Qcc D1.1 Comment #11

IEEE 802.1 Plenary, Nov. 2016, San Antonio

Traffic Class Queue Reservation in Qcc D1.1 12.31.6

Comment #11: The Over-Reservation Issue

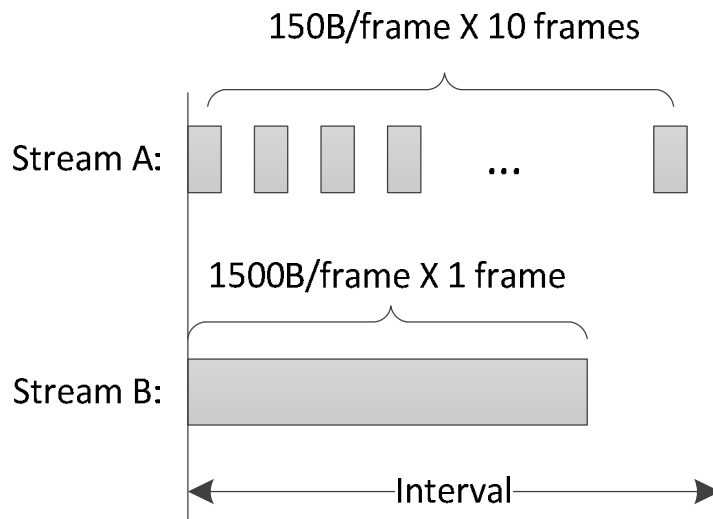
The Comment: As stated in the resolution of Qcc D1.0 comment #9, the editor suggested to use *maxFrameSize* and *maxFramesPerInterval* together with an *interval* value to specify bandwidth for a **traffic class**, based on the fact that these parameters are already used to describe the bandwidth of a single stream in TSpec. However, adopting such a set of parameters for specifying bandwidth of a traffic class consisting of multiple streams may **result in severe over-reservation**.

e.g. Stream A with 10 frames each 150B and Stream B with 1 frame of 1500B use the same bandwidth. The description of the sum will be 11 frames and max. size of 1500 Bytes, meaning 11X1500 Bytes, which is much larger than the actual 1X1500+10x150 Bytes.

maxFrameSize = 1500B
maxFramesPerInterval = 11 => **1500B X 11 / Interval**

actual bandwidth = **(150B X 10 + 1500B X 1) / Interval**

described = 5.5 X actual

- Not use the parameters in Table 12-87 for traffic class bandwidth
- Consider reusing the existing parameters or adding new parameters in Table 12-4

- Remove 12.31.6 entirely.
- Edit the Conformance column for `adminIdleSlope` and `classMeasurementInterval` in 12.20.1 to state that they are required for Stream reservation remote management.
- Add `adminIdleSlope` and `classMeasurementInterval` to 5.4.1.8.
- As needed, clarify that `adminIdleSlope` and `classMeasurementInterval` are the only features in 12.20 that do not apply to SRP (e.g. usable for fully-centralized).
